# AMENDMENT NO. 4 TO 2018 MAR -5 AM 10: 01 INTERCONNECTION AGREEMENT PERSONAL Y COMPASSION

# **FACILITY SCHEDULE NO. 13**

1. Name: Olney

#### OLNEY POINT OF INTERCONNECTION ONE-LINE DIAGRAM

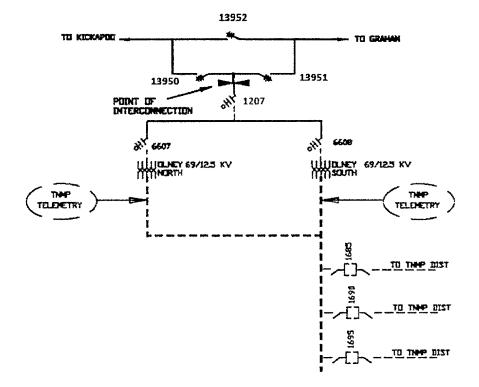
Facility Schedule No. 13 attached to the Agreement is deleted in its entirety and Facility Schedule No. 13 to this Amendment is herby added to the Agreement in lieu thereof.

Point of Interconnection is located outside the fence of TNMP's Olney substation ("TNMP's Substation") in Survey Abstract 280, Young County, Texas. The Point of Interconnection will be where Oncor's jumpers from its transmission line connect to TNMP's transmission line conductors at Oncor's three dead end poles located adjacent to Oncor's H-frame switch tap structure. (See attached single line diagram).

North Transformer Switch #6607	: <u>X</u>	_Yes/	No
South Transformer Switch #6608	<u> </u>	Yes /	No
Switch #1207:	<u>X</u>	Yes /	No
